RPP-IQRPE-50028
Revision 0

Single-Shell Tank Structural Integrity Assessment Report

Single-Shell Tank Structural Integrity Assessment Report

RPP-IQRPE-50028, Rev. 0
Single-Shell Tank Structural Integrity Assessment ReportINDEPENDENT QUALIFIED REGISTERED
PROFESSIONAL ENGINEER (IQRPE)
CERTIFICATION OF SINGLE-SHELL TANK STRUCTURAL
INTEGRITY ASSESSMENT

Figure 4-30: Tank AX-102 Differential Displacement (RPP-RPT-55202)

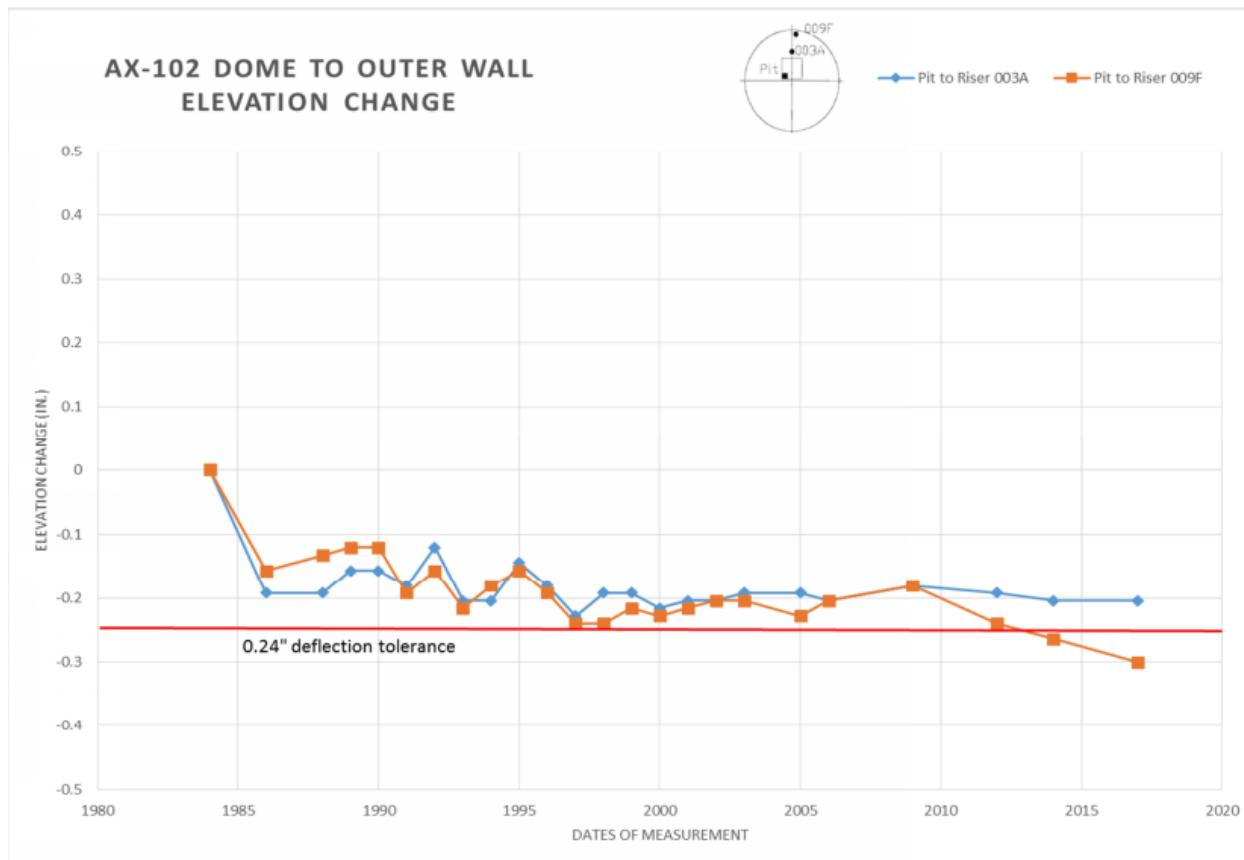
| Tank | Concern | Resolution Possibilities |
|----------------------------|--|--|
| Tank AX-102, pg 46-48 | Differential between pit and riser 009F located near the wall exceeds the 0.24" deflection tolerance. This deflection differential has been increasing since 2010. See Figure 4-30. | Conclusions of RPP-RPT-55202 Rev 02 state "Discrepancies between the true deflection and the calculated deflection can exist when the initial survey data is inaccurate. It is believed that the negative deflections measured in tanks AX-102 and B-111 were due to an early event that disrupted the benchmark elevation." pg 19 Recommend setting 1985 as the baseline to give a better understanding of the changes in deflection. |

Figure 4-31: Tank TX-103 Differential Displacement (RPP-RPT-55202)

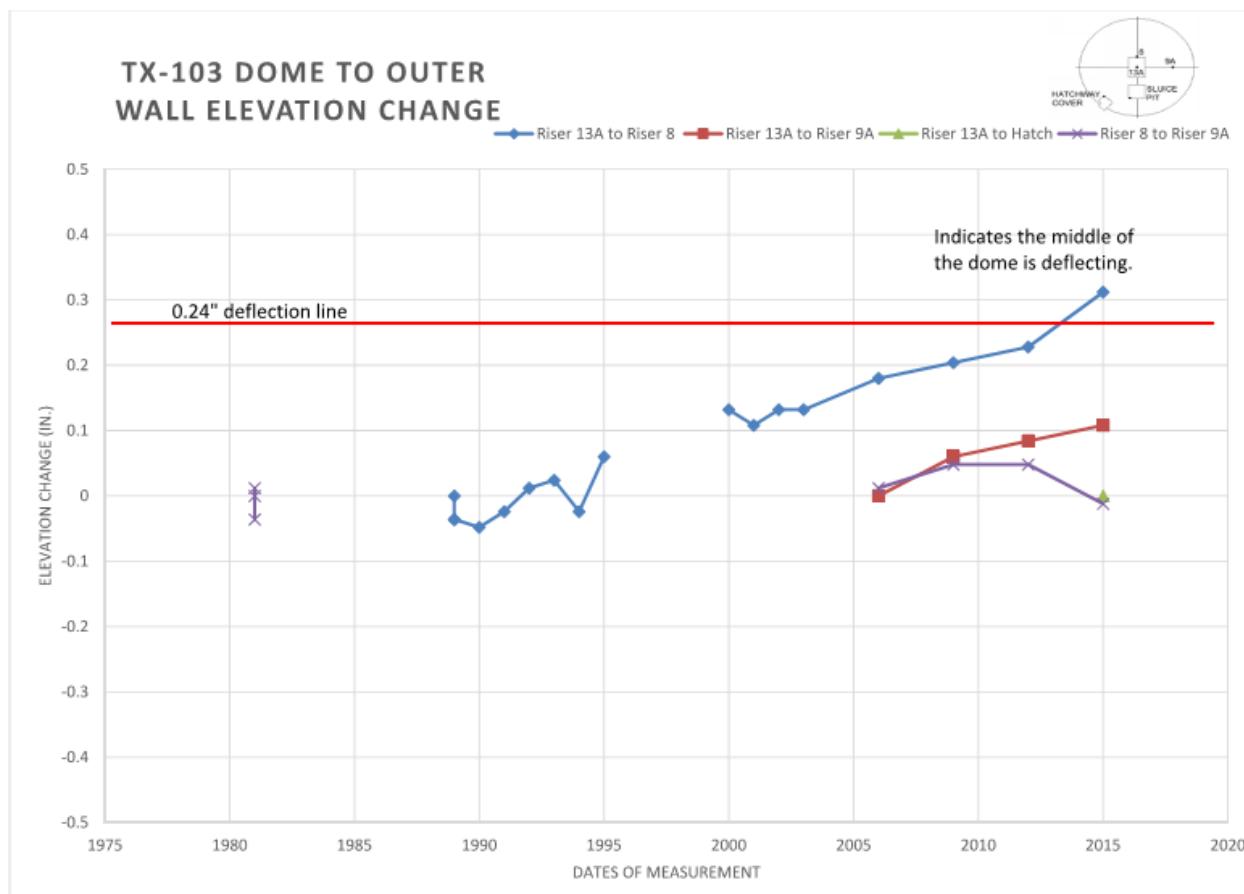
| Tank | Concern | Resolution Possibilities |
|----------------------------|--|--|
| Tank TX-103, pg 347-349 | The differential between Riser 13A and Riser 8 exceeds 0.24 in. These two risers are very close together and the pattern created by these differential deflections was not explained in the report. See Figure 4-31. | The deflections of riser 13A have been rising gradually over time signifying that this riser has moved up. It does not make sense that this would be moving up while the adjacent riser is moving down if both are fixed to the top of the dome. Recommend verifying that riser 13A and riser 8 are both affixed to the top of the dome. If these points are floating in the top of the dome, new benchmark locations that are not floating should be established. It appears that riser 8 and riser 9A are moving roughly together, therefore consider the possibility that riser 13A is not an accurate benchmark point. |

Figure 6.29: SST Type II Seismic Model BES: Soil Stresses (kip/ft²) – Vertical Component

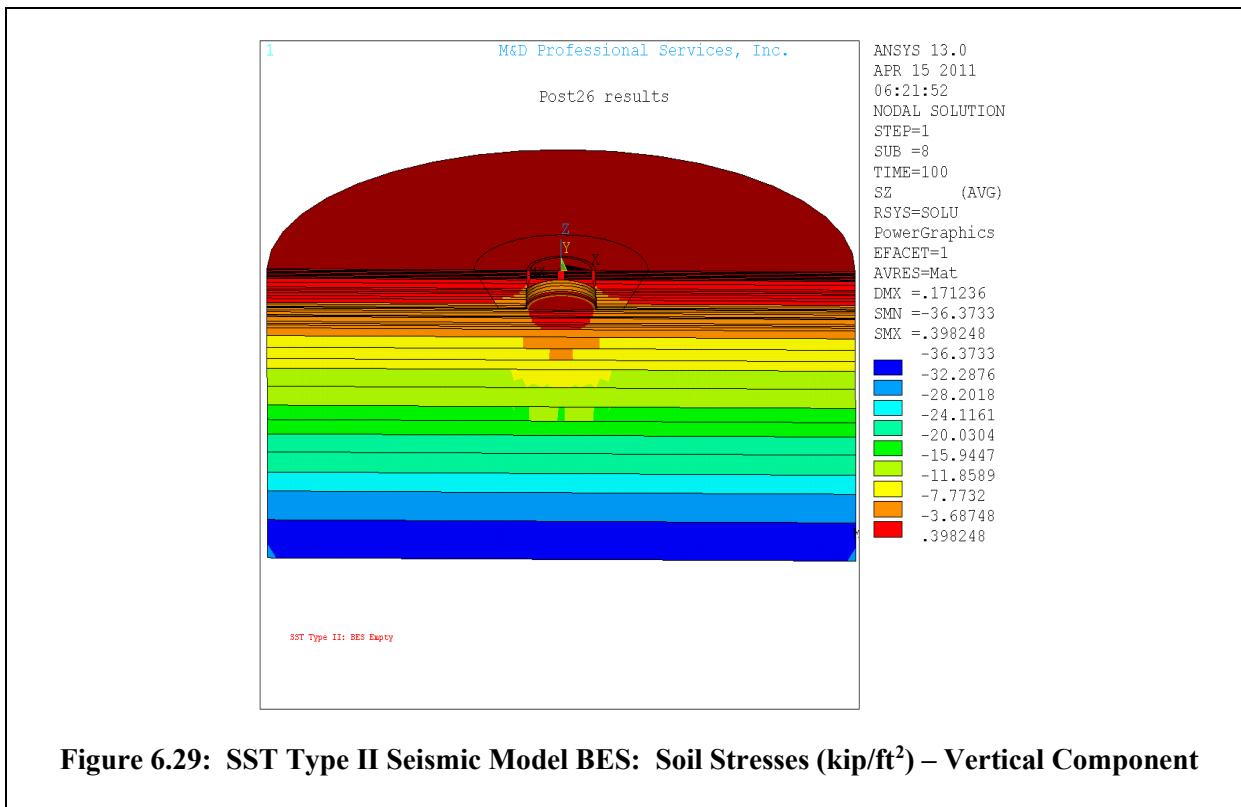
IQRPE Question: The seismic model produces 400 psf uplift at the soil surface under dead load only in RPP-RPT-49989 Figure 6.29. Can you explain these results and why they are acceptable?

PNNL Response: 0.4 kip/ft² is approximately zero for the contour range used in Figure 6.29. The finite element code first calculates the nodal forces and displacements in the soil, then the stresses at the internal integration points, and finally extrapolates the integration point stresses to approximate the nodal stresses at the surface. The nine stress contours on Figure 6.29 range from -36.4 to 0.4 kip/ft², with the red contour from -3.69 to 0.40 kip/ft². Zero is within the red contour. The 0.4 kip/ft² maximum value is shown locally in the soil at the left side of the tank dome. If finer contours were chosen with one ending at 0.0, we expect that most of the surface would be at zero, and the 0.40 kip/ft² value would be evident and localized.

Figure 6.12: Seismic Model Soil/Concrete Contact Element Normal Pressure for At-Rest Calibration – Gravity Only

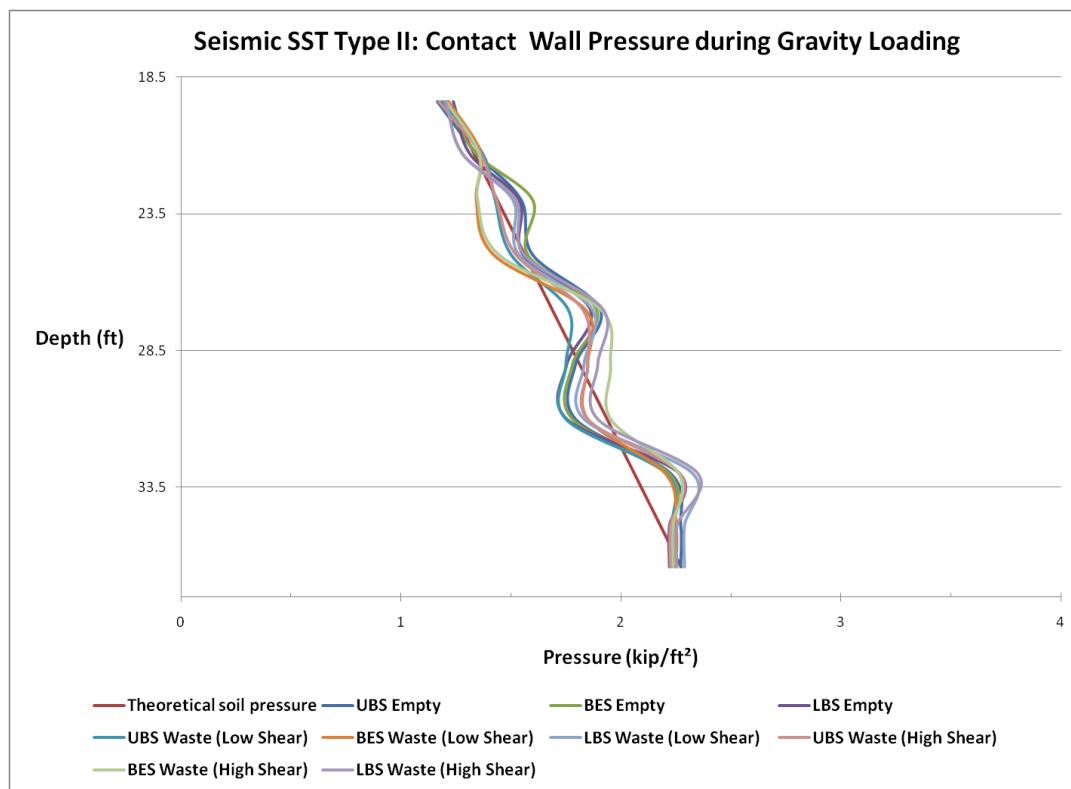
IQRPE Question: The soil pressure at the side walls produces odd at rest pressure results against the tank side walls (see RPP-RPT-49989 Figure 6.12). Appendix H discusses these results as a function of geometry of the tank. Was this phenomena also shown in the axisymmetric model or only the shell model? With a well-defined phenomenon as pressure increase along depth of soil it is odd to see a wave like distribution of soil pressure. Has this type of pressure distribution been observed/measured in real world tests?

PNNL Response: Figure 6.12 shows the approximated soil pressures from the 180° seismic model. Appendix H is the axisymmetric static model, which is actually a 3D wedge (with symmetric boundary conditions) because the STIF65 concrete elements are 3D. The waviness of Figure 6.12 is an artifact of the finite element modeling approximation. We don't expect that real-world tests would show similar behavior.

Figure 11.11: Load-Displacement Response of Nominal Concrete Under 5.8 ft of Soil with Local Load

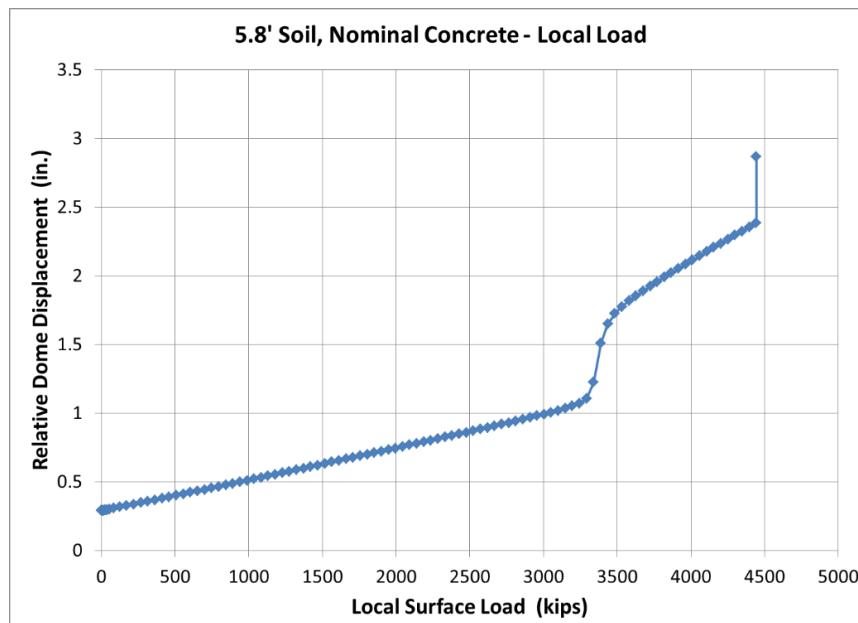
IQRPE Question: In the load-displacement response graphs for the limit analysis, what causes the non-linear behavior in each of the graphs (RPP-RPT-49989 Figure 11.11)? Based on RPP-46442 Figure 4.5, it seems that this behavior is similar to the ASME collapse load but the collapse limit line is not shown in the plots so it is difficult to discern.

PNNL Response: The nonlinear slope change in RPP-RPT-49989 Figure 11.11 load/deflection curve results from extensive cracking in the dome and the haunch concrete. The slope change is more pronounced for the local limit load cases than the uniform limit load cases.
